**BEFORE THE BOARD OF PATENT APPEALS
AND INTERFERENCES**

Application Number: 10/537,905

Appellant(s): WAHLER, TORSTEN

EXAMINER'S ANSWER

FIG 3

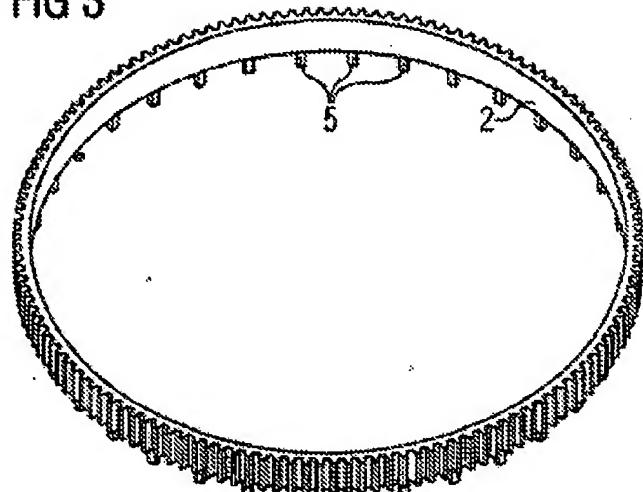
Applicant discloses a toothed band 2 which have pins 5 projecting therefrom and engaging grooves in a mating gear 7.

Applicant seems to be giving specific meaning toward "bars" and "pins." Given Figure 3 of the present invention:

The "pins" are not circular dowels projecting from the wave gear either. Also, a "pin" in this case need only be an extension for fastening. The clutch bars 6 of Fischer do apply.

FIG.6 F-F

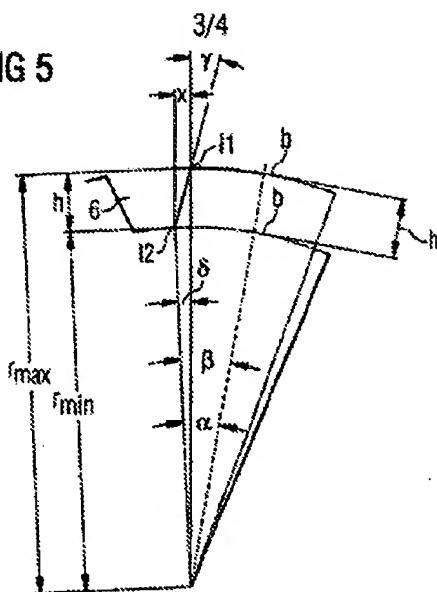
The pins engage the mating gear via grooves 6 formed on the mating gear.

FIG 5

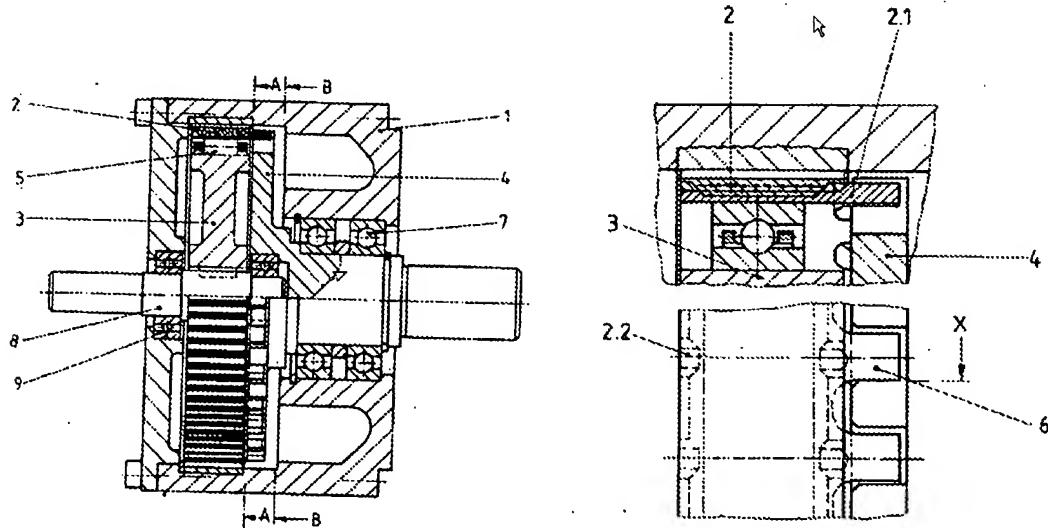
A detailed example of grooves 6 shows that the inner and outer edges do not have the same width across a radial arc.

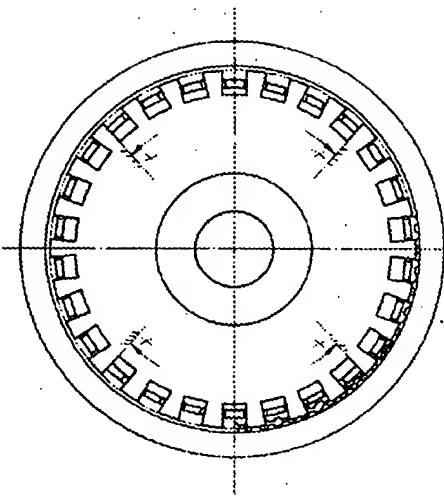
The Fischer reference also discloses a wave gear 2 with pins 6 projecting therefrom and engaging grooves in mating gear 4.

The pins sit within the grooves, but shape of the grooves are not disclosed in detail.

Fig. 1

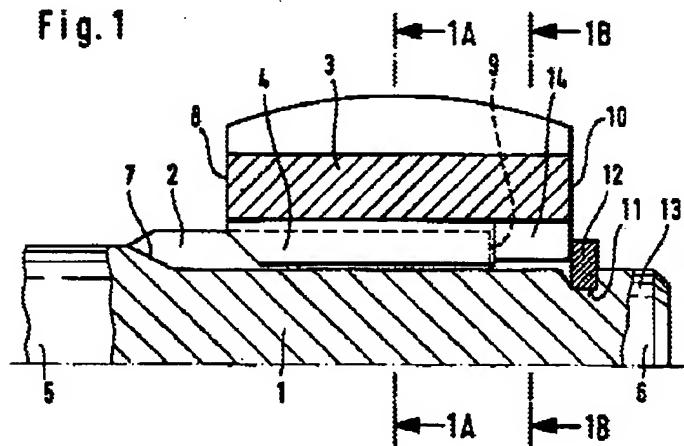
The stall reference has been brought in to teach of a specific groove 2 shape that would accommodate driving pins 4 that function in the same rotational locking manner. In the Stall reference, pins 4 are interpreted as axially projecting from the deformed portion 14, however the pins 4 are only used as a reference since the only teaching being incorporated is the groove of the mating gear.

Fig. 1a

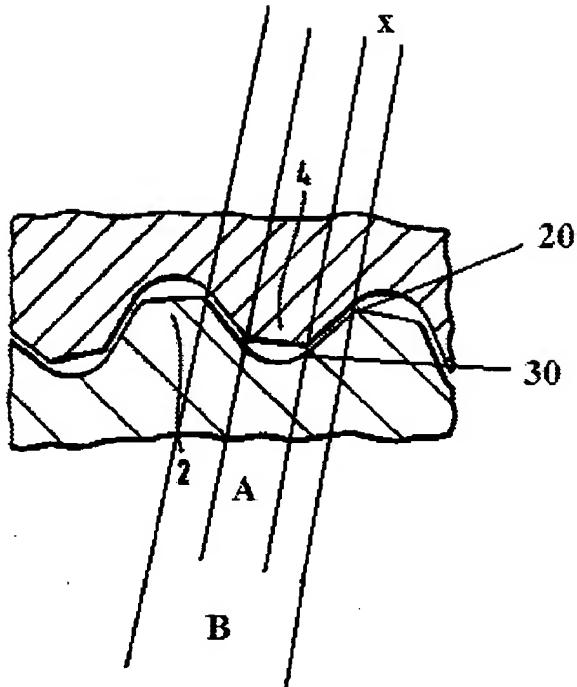
Stall teaches the groove wherein a difference (x) between the outer edge (20) and the inner edge (30) on a circular arc does not equal zero, and the difference (x) is selected so that an outer distance between opposing outer edges (20) of a groove (B) is larger than an inner distance between opposing inner edges (30) of the groove (A).

The combination of Fischer and Stall was employed for easier assembly of the transmission. Also, the substitution of one known element for another would have yielded predictable results to one of ordinary skill at the time of the invention. In this case, one groove for rotationally locking two components was substituted for another.

Fig. 1a

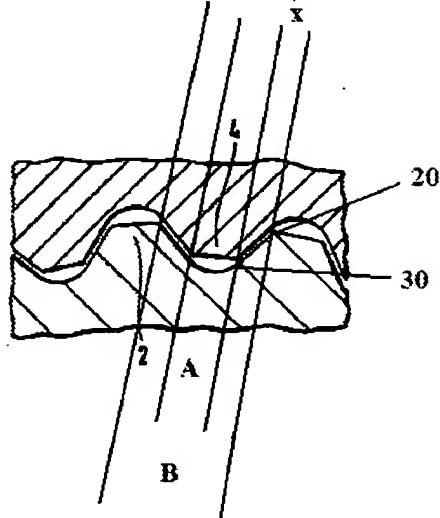
E) Applicant argues that Stall fails to teach an inner edge.

Applicant does not claim the definitions of "edge." As illustrated, the inner edge may be interpreted as the point between the groove and the straight wall of the tooth. The inner edge may also be the bottom of the groove (in which case the distance between the inner edges would be zero). Given the first interpretation (as shown in the provided figure), a difference (x) between the outer edge (20) and the inner edge (30) on a circular arc does not equal zero, and the difference (x) is selected so that an outer distance between opposing outer edges (20) of a groove (B) is larger than an inner distance between opposing inner edges (30) of the groove (A).
